ROUTE 9A - WEST STREET PROMENADE PROJECT  
 RECONSTRUCTION OF RT. 9A-WEST ST. (BATTERY PLACE TO CHAMBERS ST.)  
 MANHATTAN, NEW YORK COUNTY

FIELD CHANGE SHEETS (JUNE 6, 2012)

BATTERY PARK UNDERPASS APPROACH WALLS MODIFICATIONS

2 TYPES OF STONE VENEER PANELS (ITEM NO. 40560.3112)

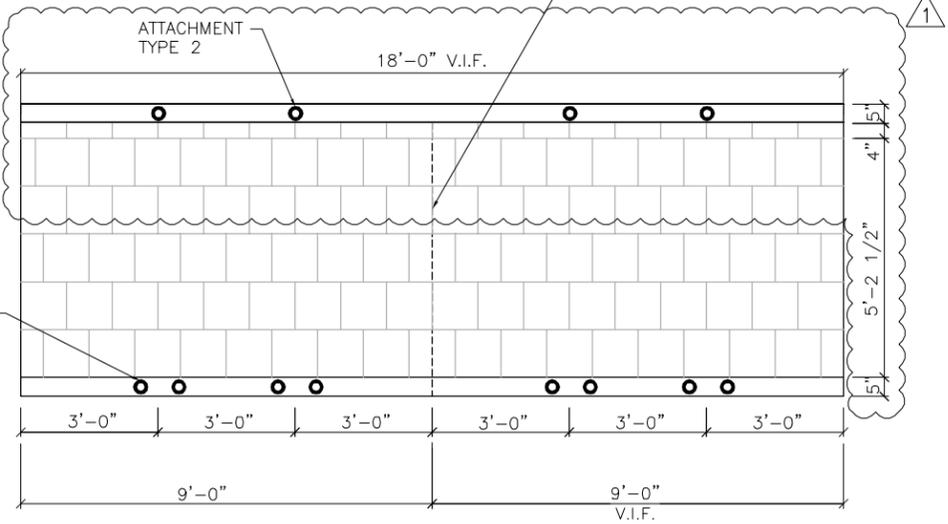
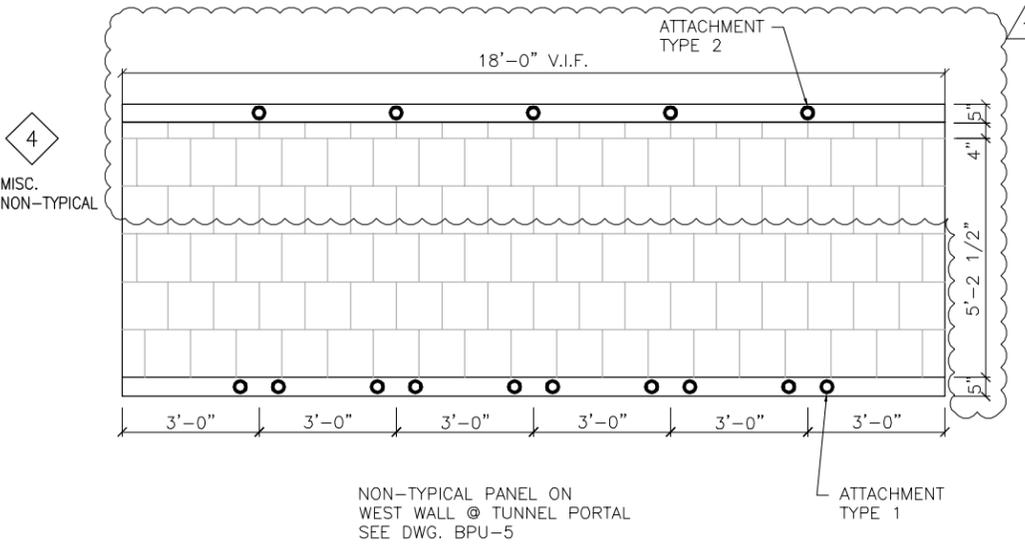
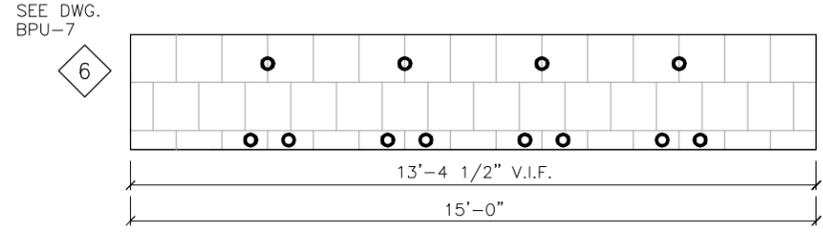
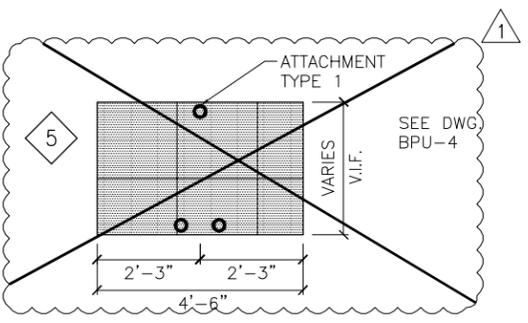
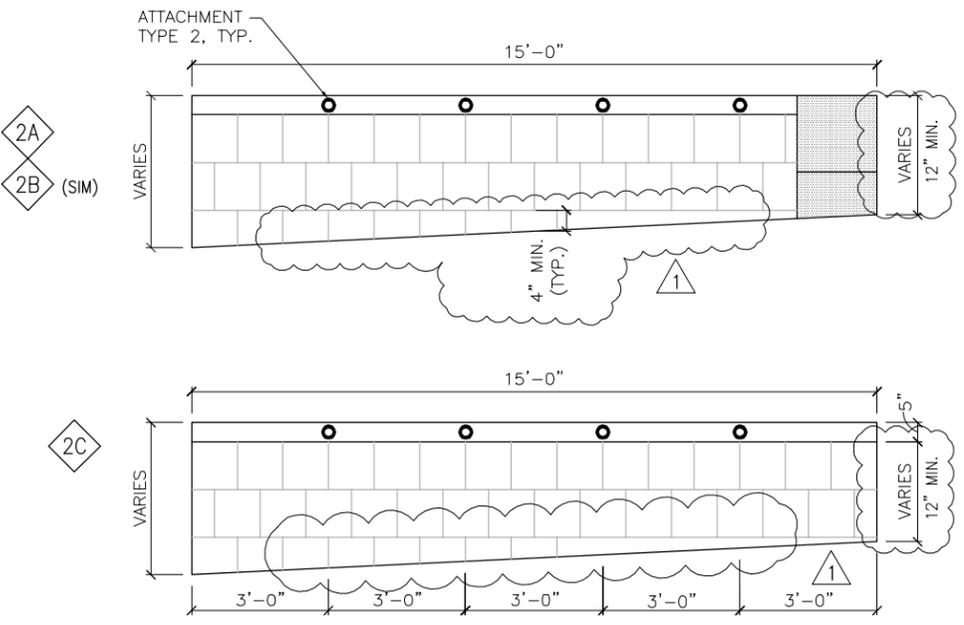
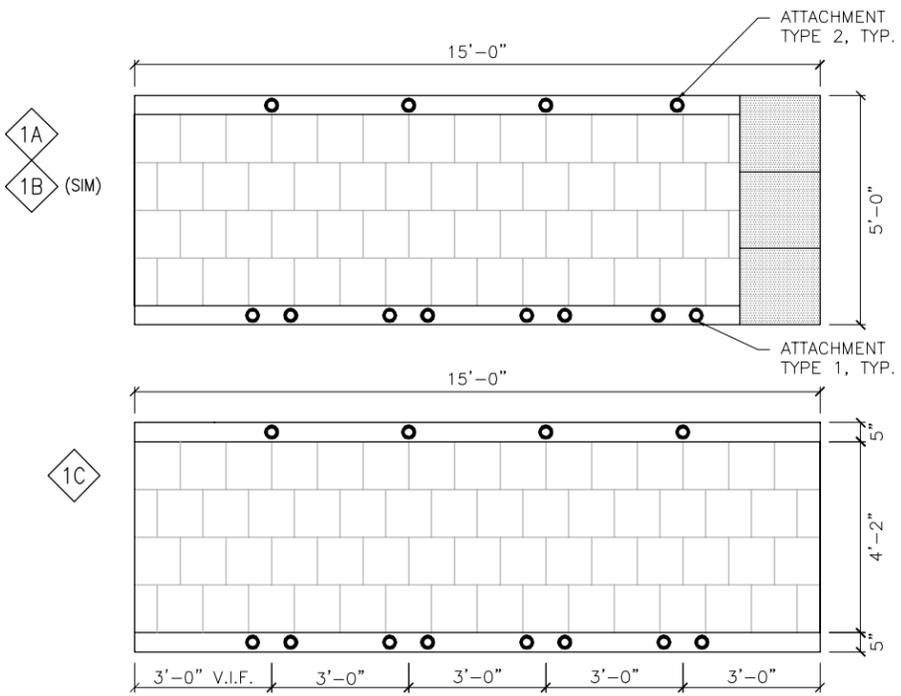
NO.	DESCRIPTIONS	DATE
1	CHANGED DETAILS	05/08/2012

- NOTES:
- JOINTS BETWEEN STONE VENEER (IN PRECAST CONC. PANEL) SHALL BE 1/2"
  - JOINTS BETWEEN PRECAST CONC. PANELS SHALL NOT EXCEED 3/4", TYP.

**PROPOSED PANEL ELEVATION (TYPICAL TRAPEZOIDAL)**  
SCALE: 1/2" = 1'-0"

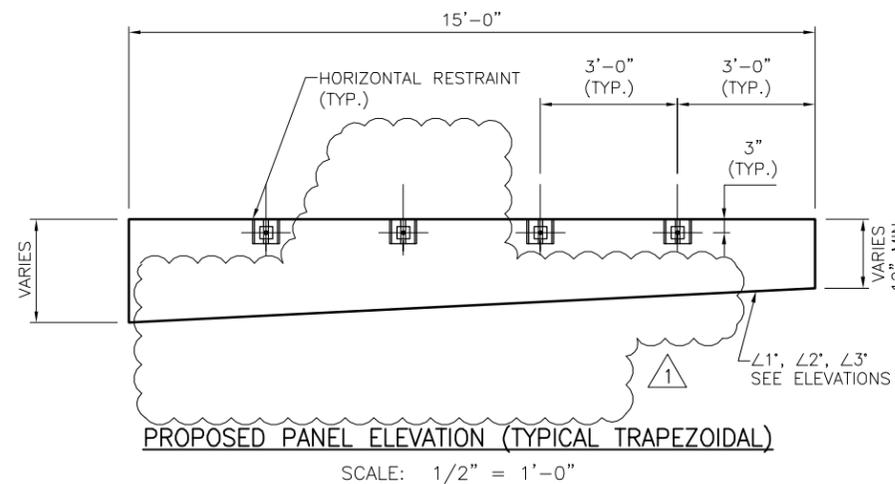
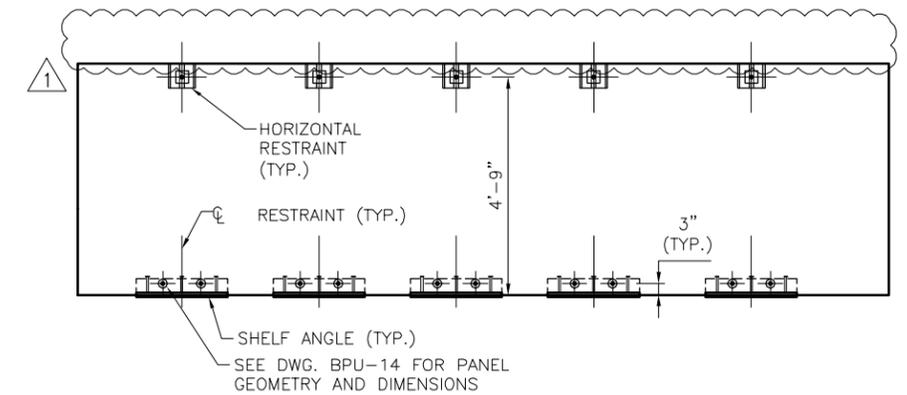
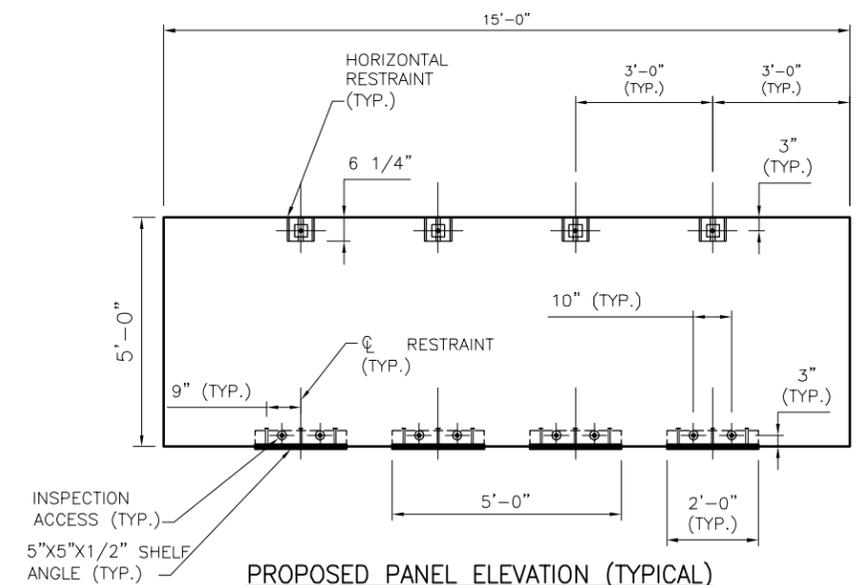
NO.	DESCRIPTIONS	DATE
1	MODIFIED PROPOSED PANEL ELEVATIONS	01/27/2012
	REVISIONS

**SOUTH (PORTAL) WALL SECTION**  
 SCALE: 1" = 1'-0"

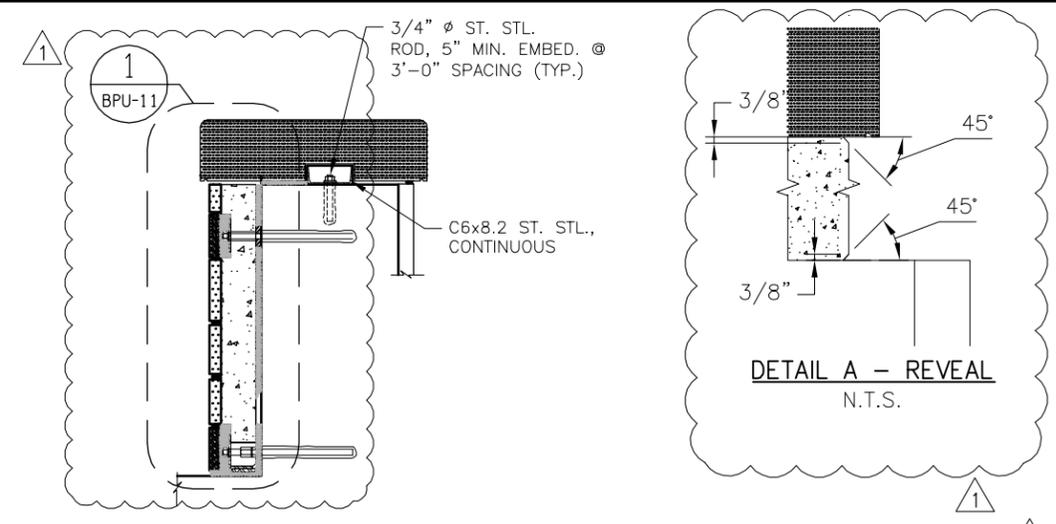
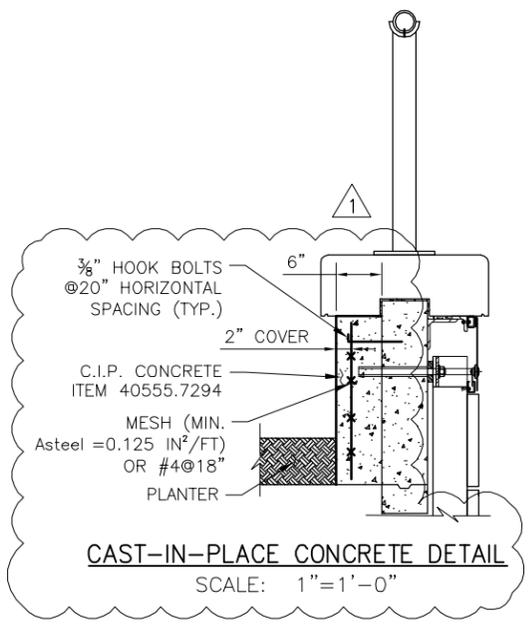
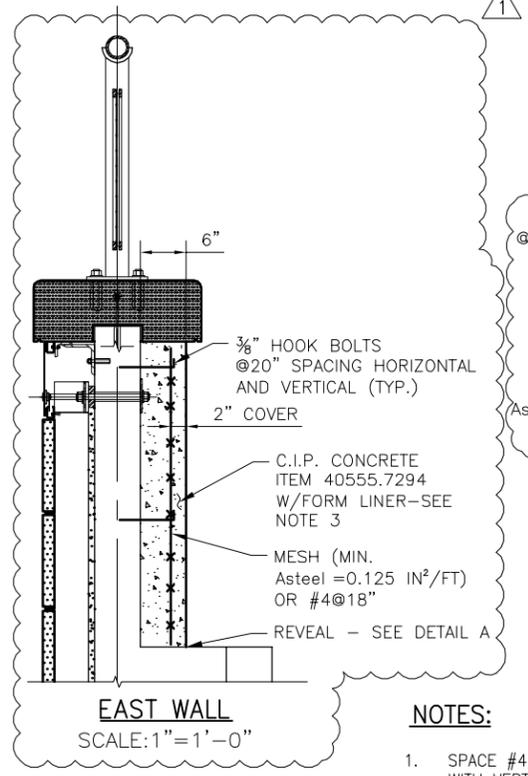
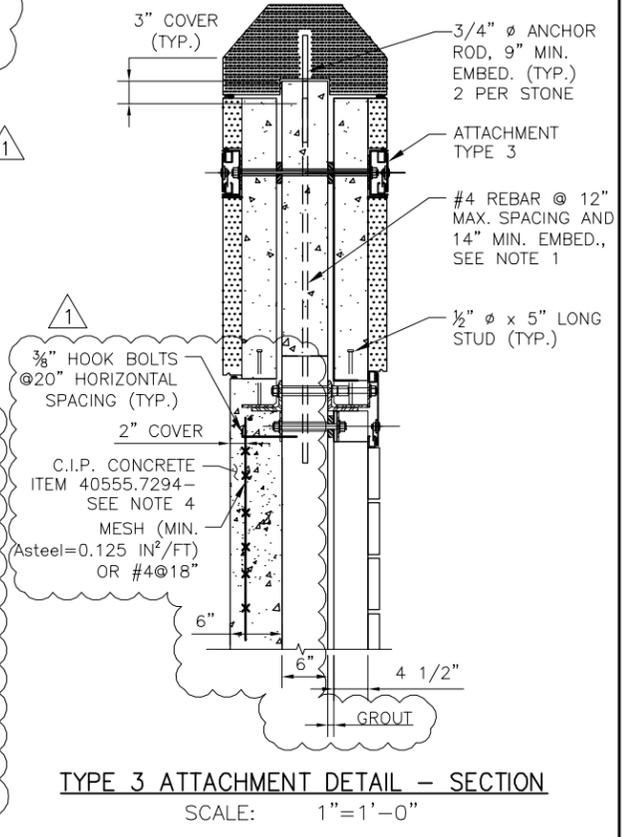
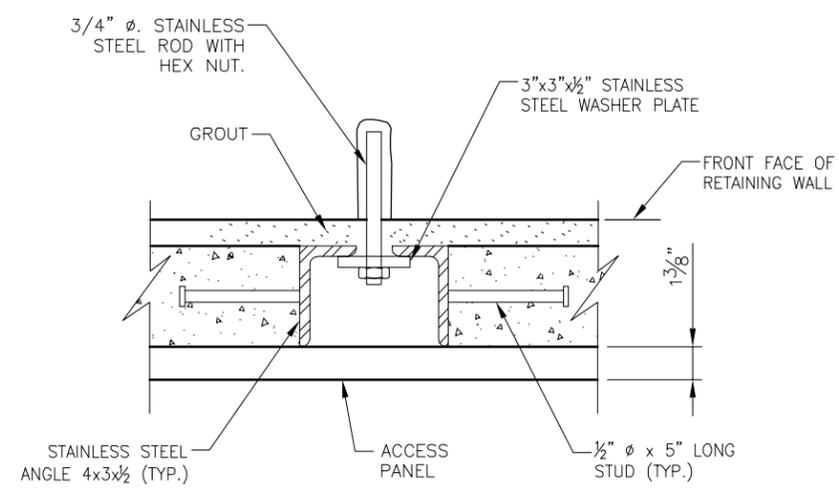
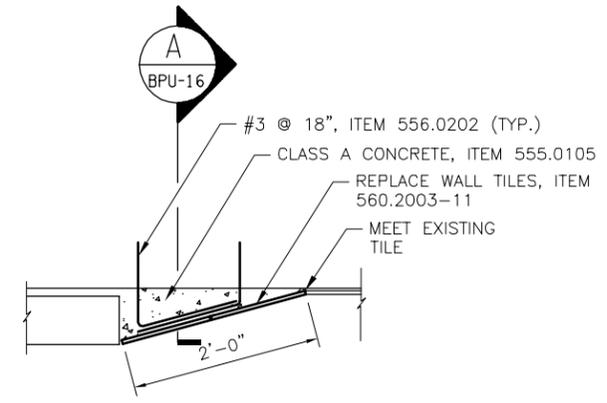
NO.	DESCRIPTIONS	DATE
1	CHANGED TO TYPICAL WALL SECTION DETAILS	05/08/2012

- NOTES:**
- SPACE #4 VERTICAL REINFORCING BARS TO AVOID INTERFERENCE WITH VERTICAL COPING STONE ANCHORS AND HORIZONTAL ANCHOR RODS. PROVIDE MIN. 2" EDGE DISTANCE TO HOLES OF HORIZONTAL ANCHOR RODS.
  - FOR PANEL DESCRIPTIONS, SEE DWG. BPU-12 AND BPU-13.
  - FORM LINER TREATMENT SHALL BE #T316 FINE SANDBLAST BY CUSTOMROCK OR APPROVED EQUAL.
  - CAST-IN-PLACE CONCRETE SHALL EXTEND 1'-0" BELOW BOTTOM OF COPING STONE ELEVATION ON WEST WALL.
